ACCESSIBILITY CAPABILITY STATEMENT FOR DA SUBMISSION
PROJECT NAME: 10-16 BIRDWOOD AVENUE, CABRAMATTA WEST

Seniors Housing Assessment Report

Project: Seniors Housing Development
10 – 16 Birdwood Avenue
Document Type: Housing SEPP Design Assessment Report
Our Reference: P223_382-1 (Seniors Housing) DY

ACCESS CONSULTANCY SERVICES – SCHEDULE 8 CLAUSE 6 (SEPP) 2021 AND CLAUSE 93
PROJECT NAME: 10 BIRDWOOD AVENUE, CABRAMATTA

Figure 1 – Location of bus stops

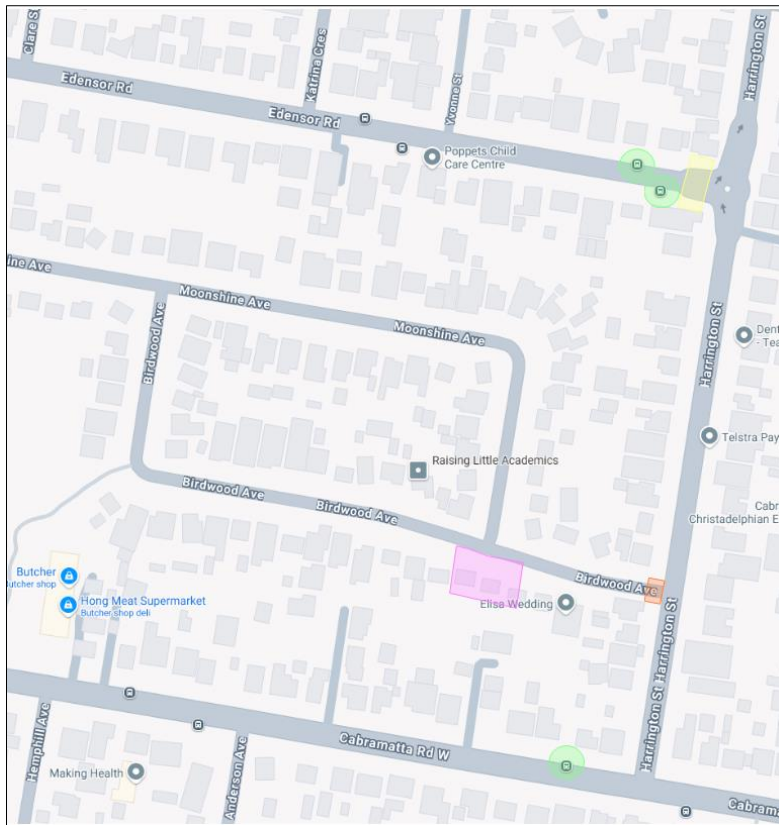
It has been identified that three (3) bus stops are located within the maximum permitted distance from the subject development, being 400m. These bus stops are all located along Harrington Street and Cabramatta Road identified in **green** within the below **Figure 1**.

As identified in the document made available for this assessment, a concrete path is provided along Birdwood Avenue and Harrington Street to all bus stops as indicated in the above **Figure 1**. The width of the existing concrete path is ~1000mm – 1200mm and has a gradient of no steeper than 1.8% or ~1:56. The mean gradient along the footpath the closest bus stop is calculated at being less than 1% or ~1:180, which is considered to be a 'flat' landing within the AS 1428 suite (which covers design for access and mobility) hence achieves compliance with Schedule 8, Clause 6 and Clause 93 of the SEPP.

From the subject site, suitable kerb ramps has been provided to cross Birdwood Avenue and Harrington Street intersection (highlighted **orange**) and Harrington Street and Edensor Road intersection (highlighted **yellow**). Kerb ramps have been provided so that it is possible to for a person in a wheelchair to easily cross the road to get to and from the bus stops when wanted to travel in different directions on the bus services. Refer to **Figure 2** below for installed kerb ramp which is located near the intersection of Harrington Street and Edensor Road.
